Project Name: Condominiums at Columbia

Project Number #: 17-5161

CONCEPT Design Review

CITY OF OLYMPIA
MULTI-FAMILY RESIDENTIAL
Chapter 18.170

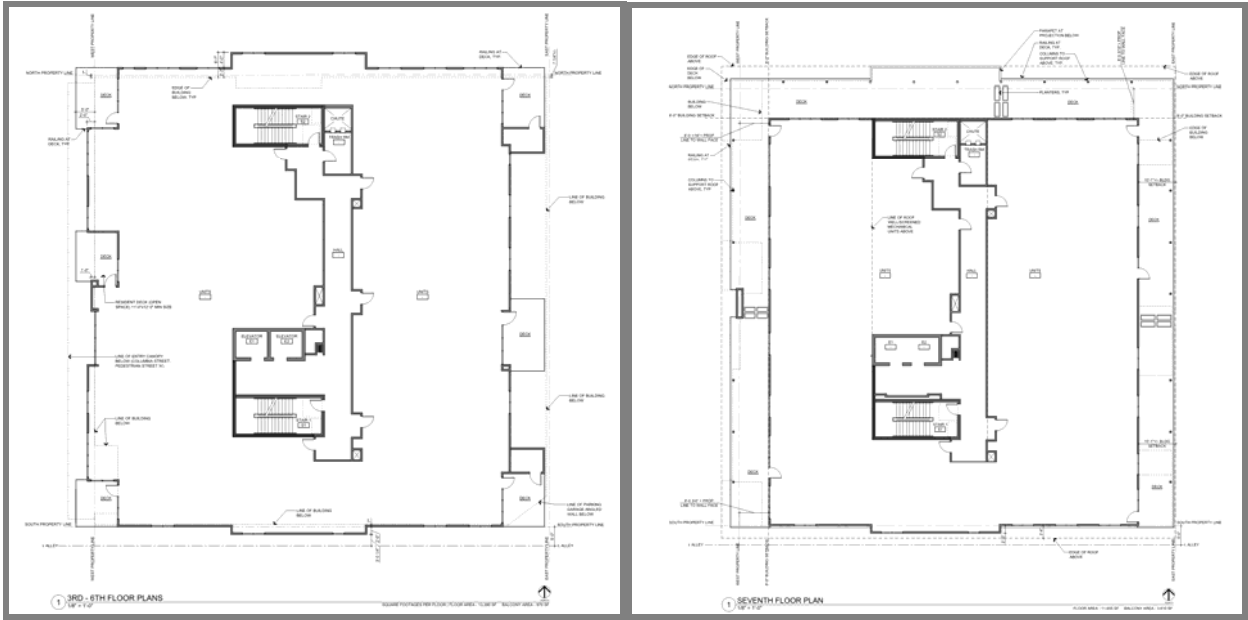
Bicycle parking is shown along the Columbia Street façade in the Site Plan, Sheet A010. However, the Landscape Plan depicts the bicycle parking in a different location. The project is required to have three covered stationary racks, shown in the same location on both the Site Plan, Sheet A010, and the Landscape Plan, Sheet LS-01.

1. *Provide design details of the decorative grill screening over parking garage openings in the building, and of the coiling overhead garage doors (2).*
2. *Update the Site Plan, Sheet A010, and the Landscape Plan, Sheet LS-01, with the location of the short-term bicycle parking stationary racks (i.e., along Columbia Street and/or Thurston Avenue?).*
3. *Incorporate building design elements in the building or sidewalk that alert drivers and pedestrians to vehicles entering and exiting from the two parking garage entries.*
